Huntington Beach Energy Project

(12-AFC-02)

Resubmission of Data Responses, Set 1B, 4, and 5

(Updated Responses to Data Requests 23 to 26
[Biological Resources], 104 to 106 [Air Quality], and
107 to 109 [Public Health])

Figure DR25-1R: HBEP Total Nitrogen Deposition on Surrounding Habitats

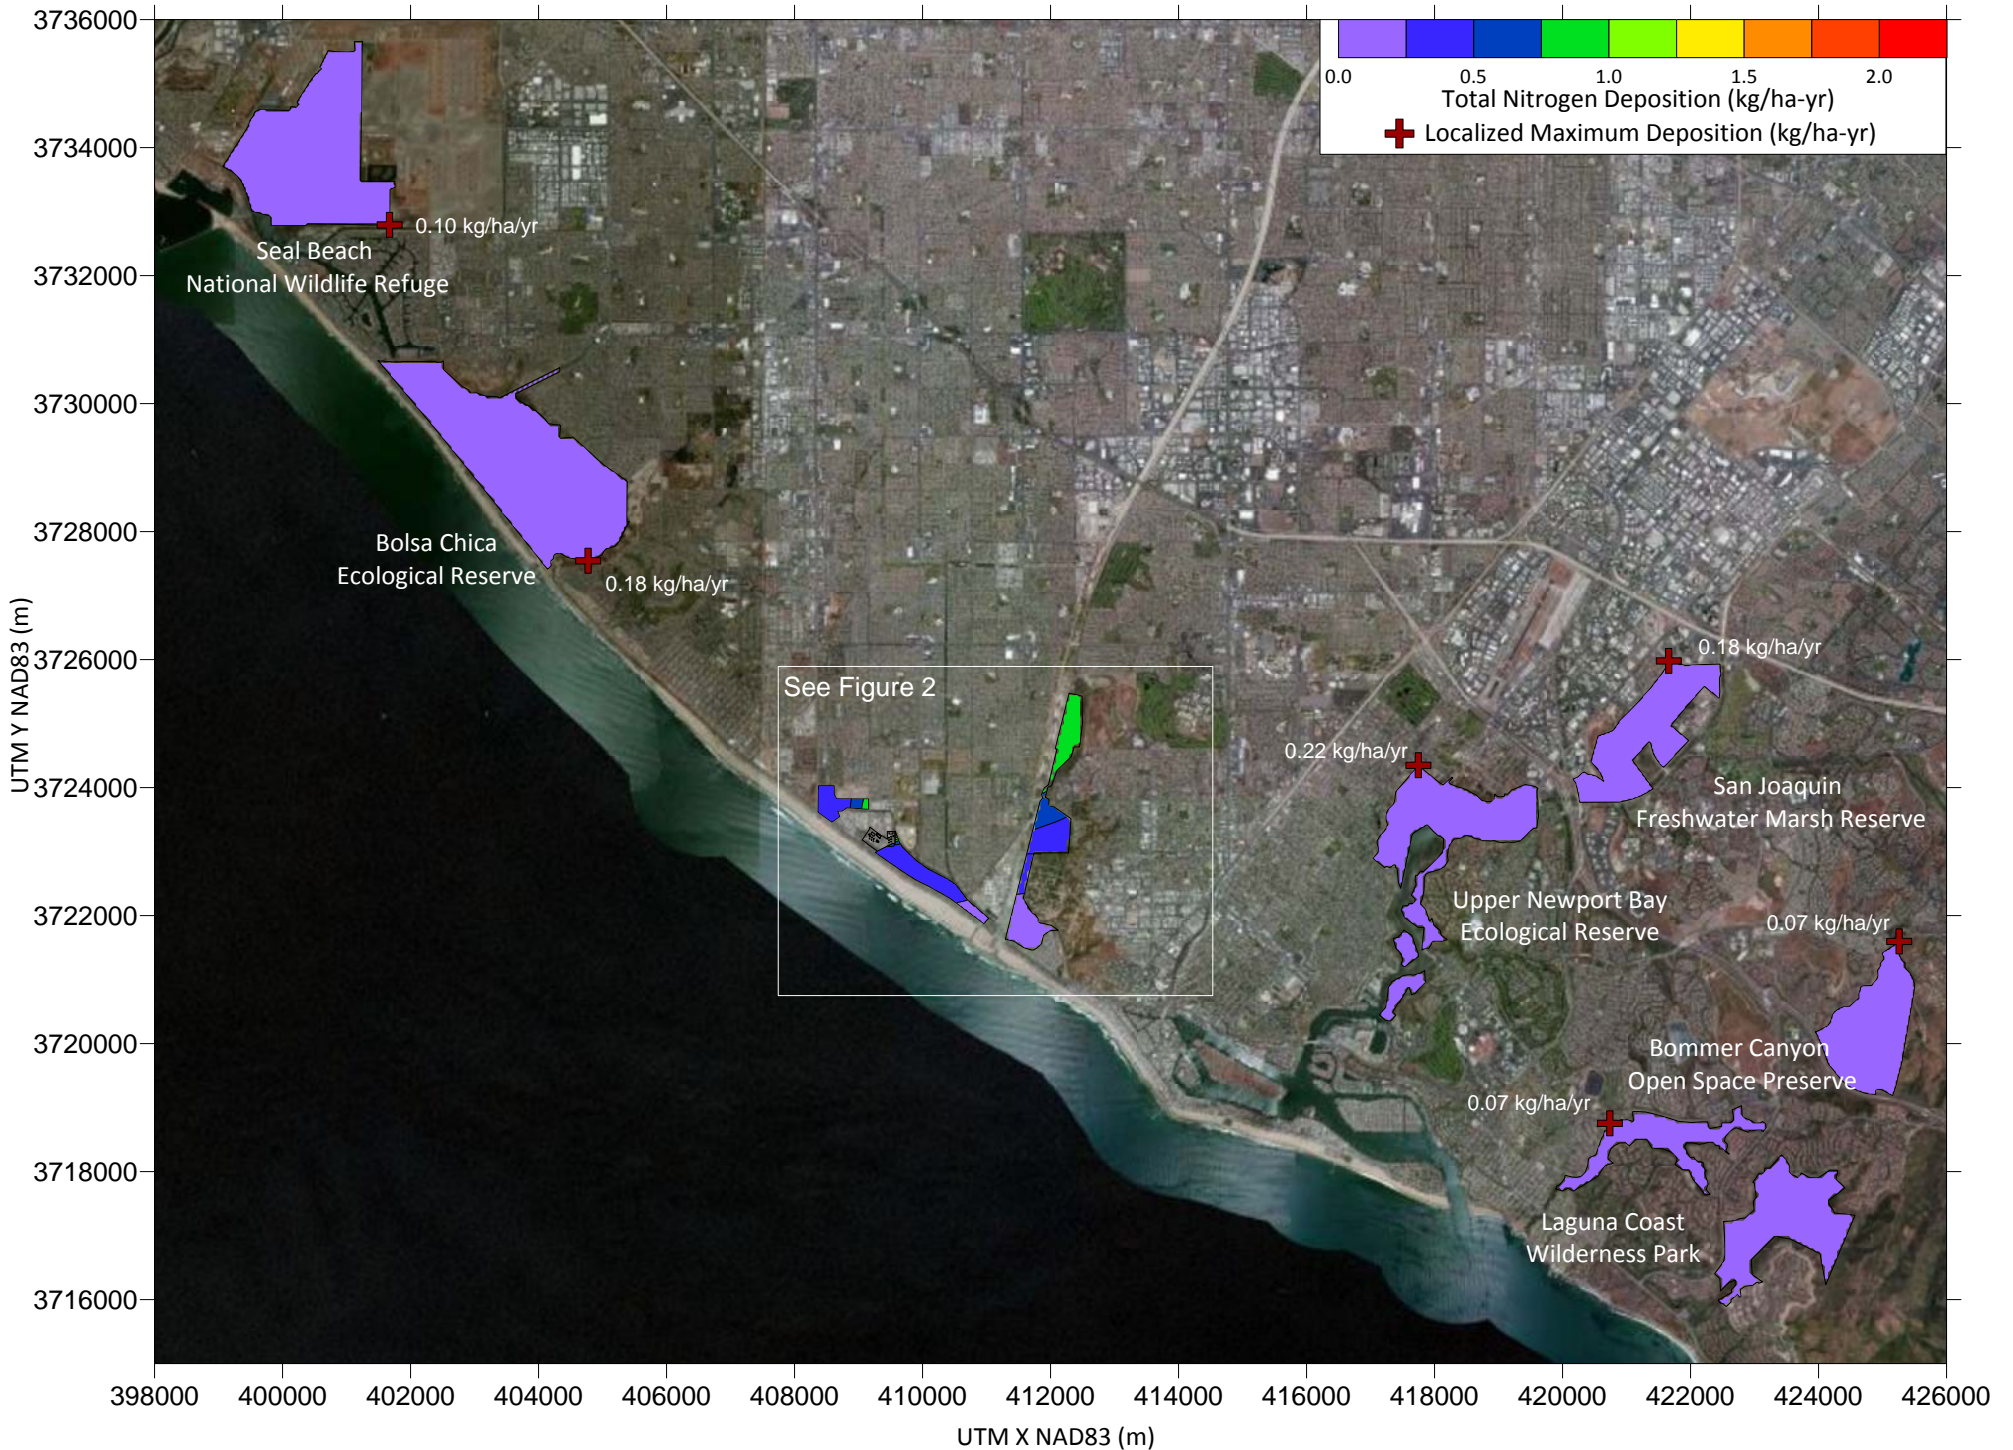
25. Please provide an isopleths graphic over U.S. Geological Survey (USGS) 7.5-minute maps (or equally detailed map) of the direct nitrogen deposition rates caused by the project. This will be a graphical depiction of the projects’ nitrogen deposition.

Response: The predicted nitrogen deposition flux isopleths are included in Figures DR25-1R and DR25-2R provided herewith.

Figure DR26-1R: HBEP Cumulative Nitrogen Deposition on Surrounding Habitats

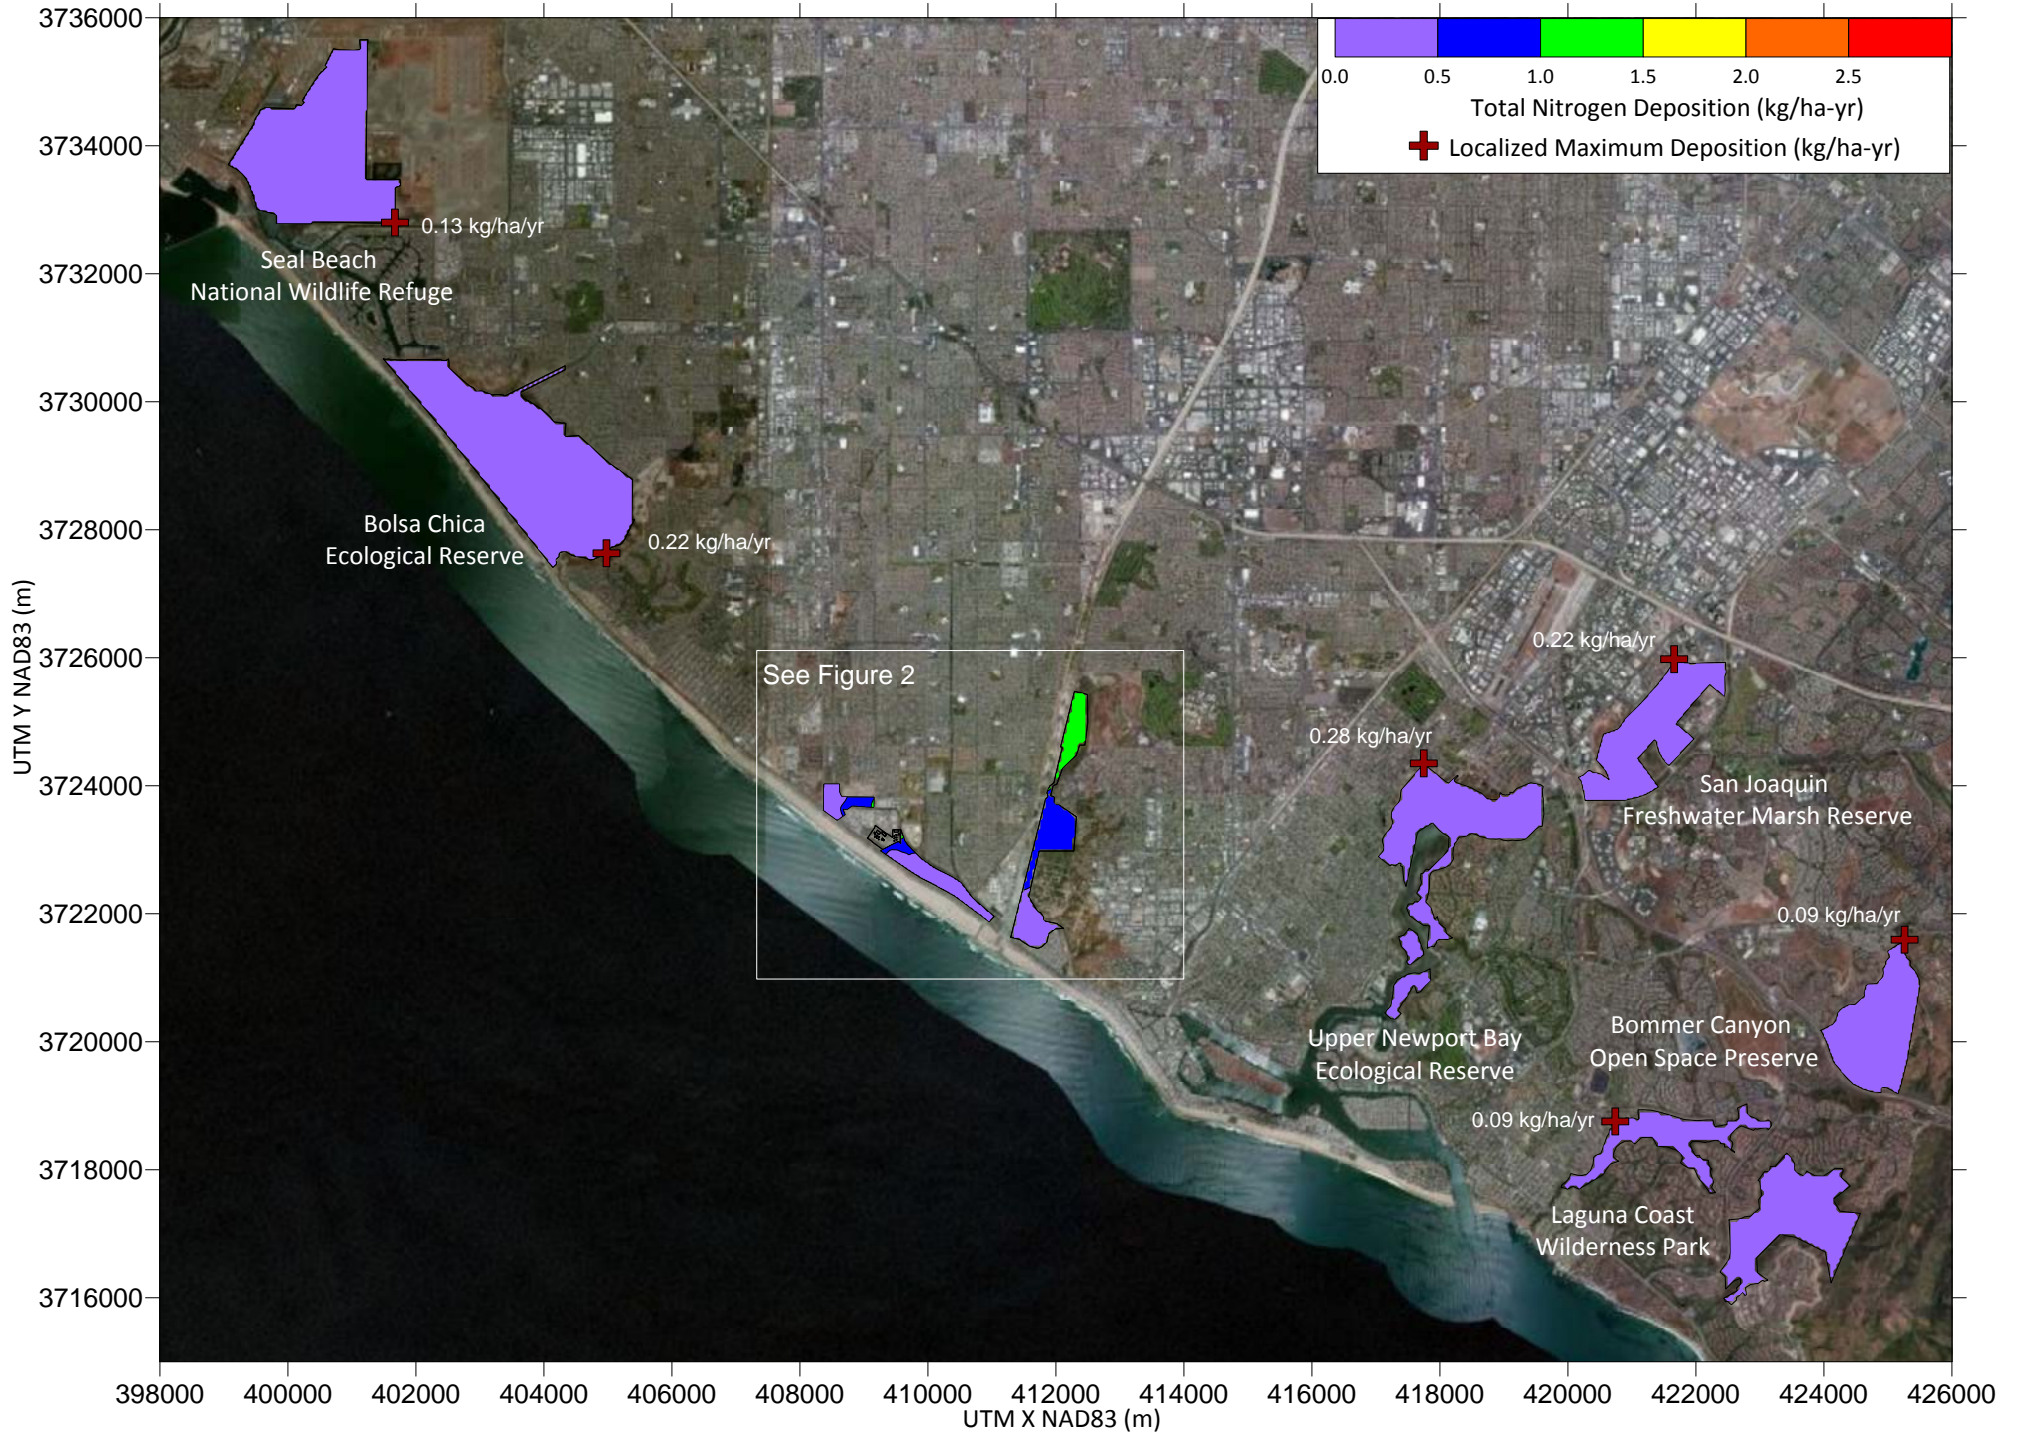
26. Please provide a comprehensive cumulative impact analysis for the direct nitrogen deposition in kg-N ha⁻¹ yr⁻¹ caused by HBEP. Provide an isopleths graphic over USGS 7.5-minute maps of the direct nitrogen deposition values in the cumulative analysis and specify the cumulative nitrogen deposition rate in kg-N ha⁻¹ yr⁻¹ at any affected special status habitat, vegetation type, or critical habitat. The geographical extent of the cumulative nitrogen deposition mapping should be directed by the results (i.e., extend geographically to where the deposition is considered below any stated threshold of significance).

The dispersion modeling files, which include input and output files used in the analysis, have been included with this submission on compact disc. The predicted nitrogen deposition flux isopleths, which include the maximum predicted nitrogen deposition flux and the location within each of the sensitive areas, are included in Figures DR26-1R and DR26-2R.
